HOWARD COUNTY OFFICE OF PLANNING AND ZONING
DIVISION OF LAND DEVELOPMENT
COUNTY OFFICE BUILDING
3450 COURT HOUSE DRIVE
ELLICOTT CITY, MARYLAND 21043

RE: NICHOLS PROP

Nichols Property Sketch Plan

SKETCH PLAN
NICHOLS PROPERTY
TAX MAPS 28 & 34 PARCEL 1
5th Election District
Howard County, Maryland

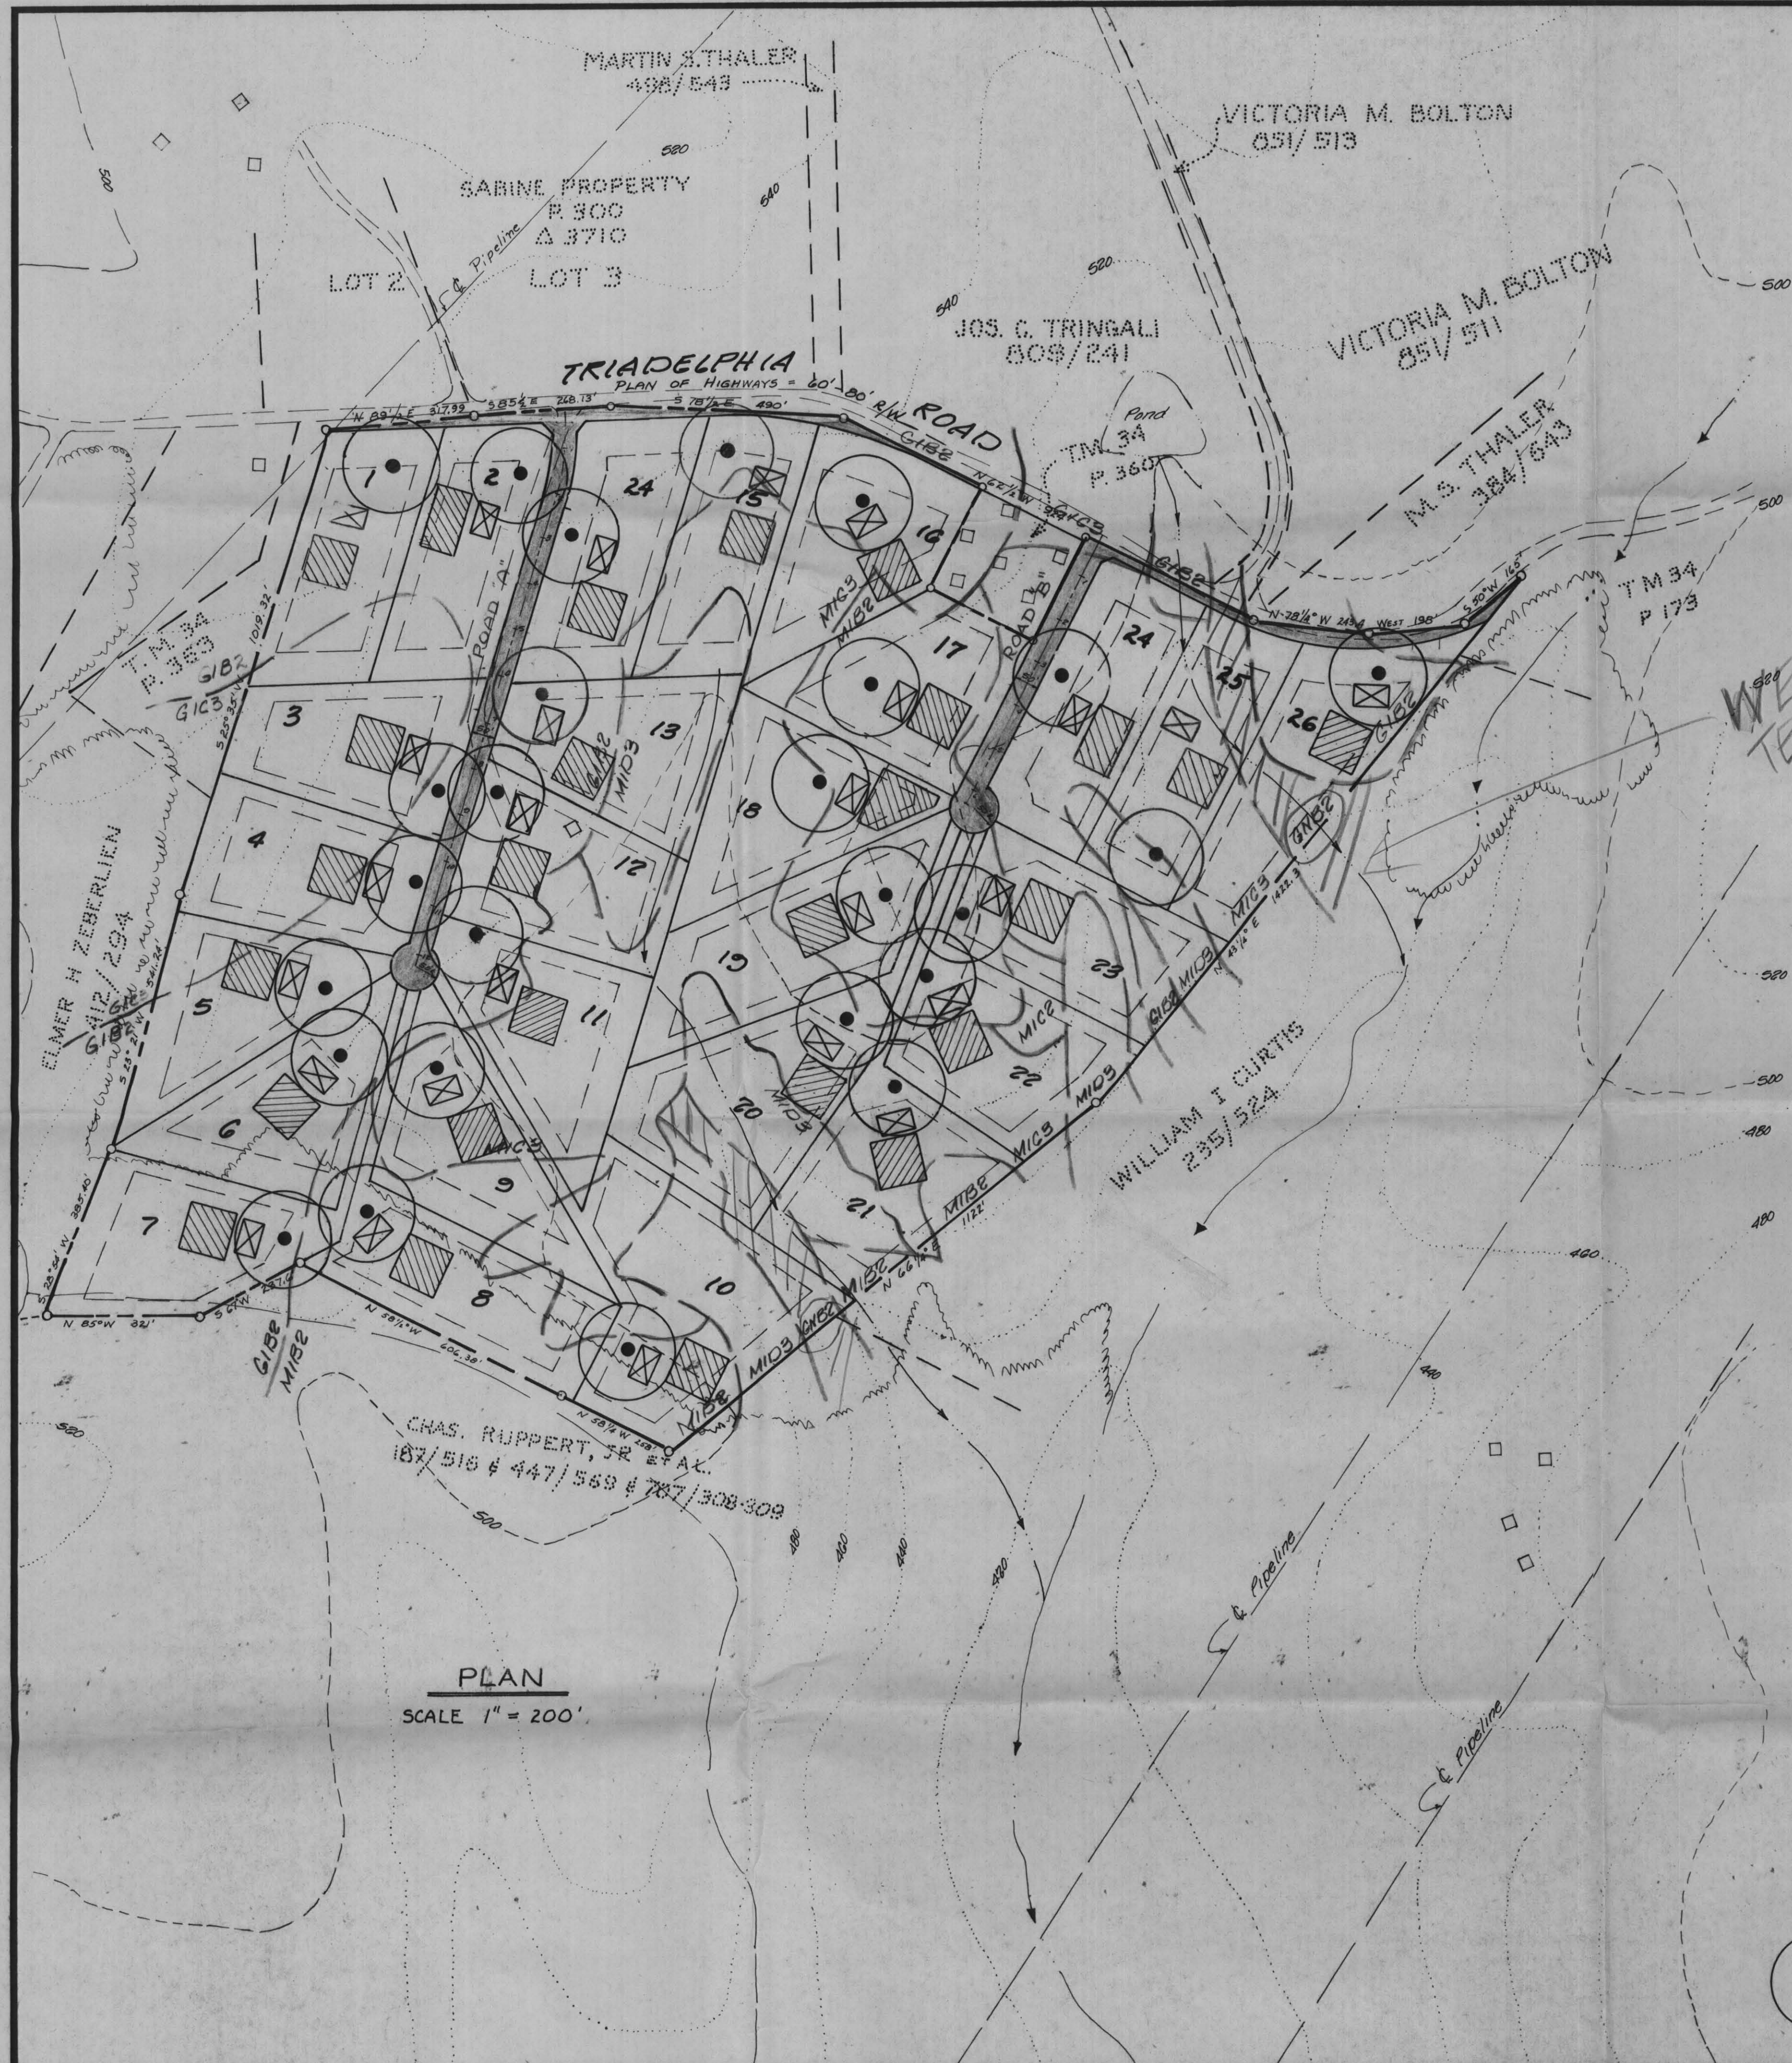
Prior to our review & comments a sketch plan with 2 foot contour is required; no percolation test application can be accepted without it.
